Project: 1694 - Asylum
 121 Center Street
 Portland, Maine 04103

Submittal #323900-003237416.11-001.0
237416.11 - PACKAGED SMALL-CAPACITY ROOFTOP AIR-CONDITIONING UNITS

P/D: Small Capacity RTUs 1-6 (Para 1.4A, 2)

DESCRIPTION:
 Note substitution request for RTU 4 and 5 based on sizing and load requirements.

System ID: RTU-4, 5 2-TON
 Package Model: KGB024S4D

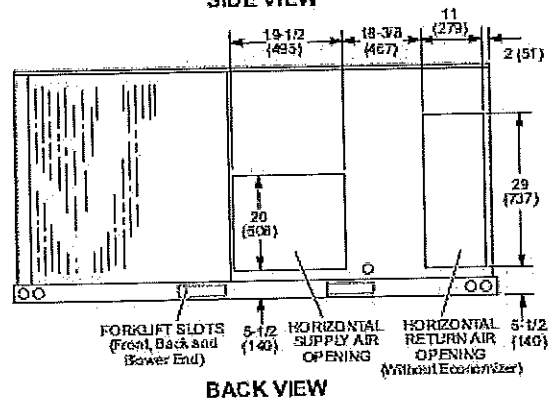
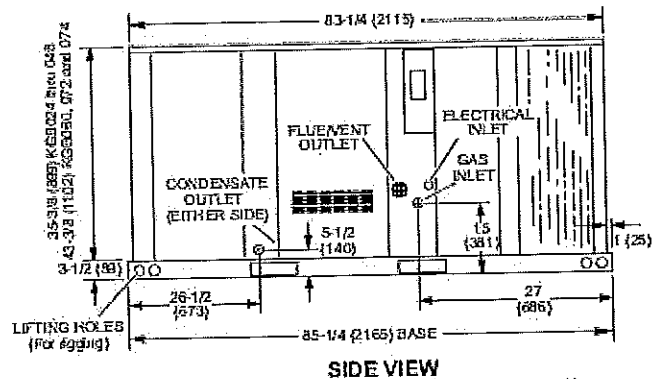
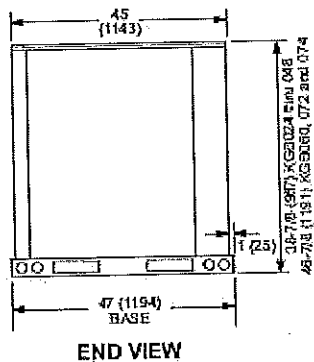
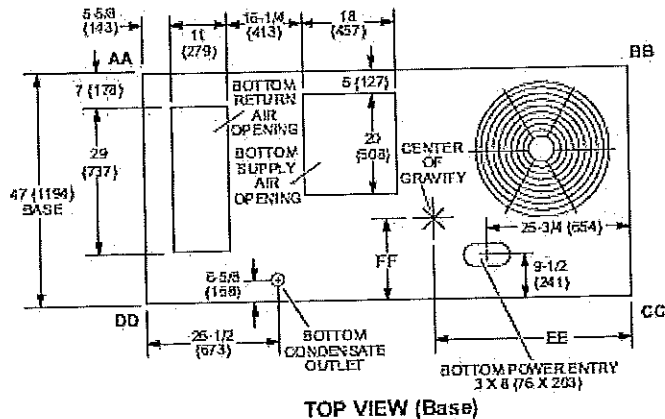
These (2) units are scheduled as 3 Ton units with 108 MBH gas heat, 700 CFM. While the fans can operate at this low cfm (during economizer mode for example), with such a low face velocity across the DX coil there is danger of freezing the coil. Also, the furnace has a maximum 70F temp rise, with 108 MBH it would require much higher CFM to keep the unit from exceeding the 70F max temp rise, the unit would trip on high limit. The heat load for the spaces served by these units is less than the 3 tons and 108 MBH specified. I believe the 3 ton units were scheduled as model LGH036 units to keep all of the units in the same series, the Emergence series, which starts at 3 tons. The Landmark series has a 2 ton unit that can more closely meet the heat and cooling load requirements and provide 700 CFM as needed.

Differences between proposed substitution and specified product: Scheduled units are 3 ton, proposed substitution are 2 ton. The 2 ton units provide more than enough capacity for the spaces served. The 2 ton units will not have hot gas reheat. They are a different series unit, the are the Landmark series versus the Emergence series. The Landmark series do not have a microprocessor controller but will come with the Comfort Sense 7500 controller as is typical will all of the RTUs. The unit sizes, and weights are virtually identical.

Reason for not providing specified item: The specified units are scheduled at only 700 CFM, while the fans can run that low there is a danger of freezing the DX coil at such a low face velocity, also the heat exchanger can handle a 70F temp rise, with such a low CFM, the unit will likely trip out often on high limit due to exceeding the 70F max temp rise.

| <input checked="" type="checkbox"/> 1 - Reviewed, No Exception Taken | |
